Access Compliance Report

Public Rights-of-Way

(Curb Ramps)

Intersection ID: 50582	Main Street: DOWNY_BIRCH_RD	Cross Street: PAPER_TREE_RD	Location: SW
ADA ID: 601468ABC095	Ramp Type: Perp	Initial Pass/Fail: Fail	Overall Compliance: No
Codes/Mitigation Info/Possible Solution		Field Measurements/Component Compliance	
Severity Score: 22.5

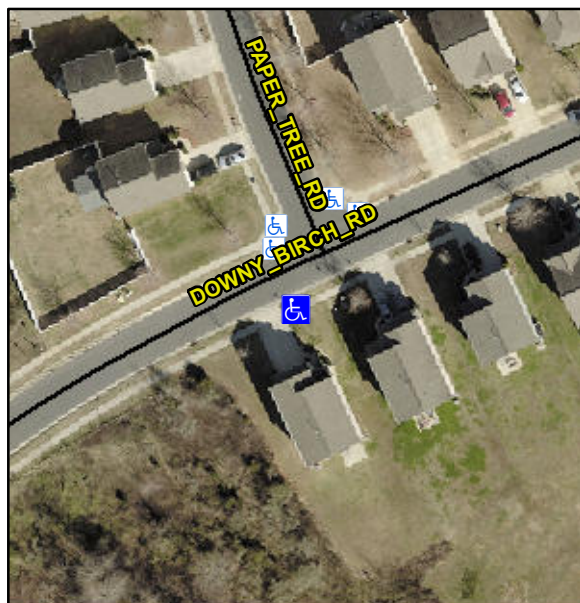
Not Found, R304.5.1, R304.2.2

Compliance	Description	Data	Compliance	Description	Data
N/A	Ramp Length (in)	47.0	No	Ramp Slope (%)	9.3
No	Ramp Width (in)	47.5	Yes	Ramp XSlope (%)	2.9
N/A	Flare Type LT	N/A	N/A	Flare Type RT	N/A
N/A	Flare Slope LT (%)	N/A	N/A	Flare Slope RT (%)	N/A
N/A	Flare Traversable LT?	N/A	N/A	Flare Traversable RT?	N/A
N/A	Landing Length (in)	N/A	N/A	DWS Provided?	N/A
N/A	Landing Width (in)	N/A	N/A	DWS Contrast?	N/A
N/A	Landing Slope (%)	N/A	N/A	DWS Length (in)	N/A
N/A	Landing X Slope (%)	N/A	N/A	DWS Full Width?	N/A
N/A	Landing Curb? (Y/N)	N/A	N/A	DWS Offset (in)	N/A
N/A	Shared Landing?	N/A			
N/A	Gutter Ponding?	N/A	N/A	Gutter Slope (%)	N/A
N/A	Gutter Lip Ht (in)	N/A	N/A	Gutter X Slope (%)	N/A
N/A	Painted X Walk1?	No	N/A	Painted X Walk2?	N/A
	X Walk 1 Direction	To N		X Walk 2 Direction	N/A
N/A	X Walk 1 Width (in)	N/A	N/A	X Walk 2 Width (in)	N/A
	X Walk 1 Slope (%)	0.6		X Walk 2 Slope (%)	N/A
	X Walk 1 X Slope (%)	3.6		X Walk 2 X Slope (%)	N/A

Remove & Replace Entire Ramp.
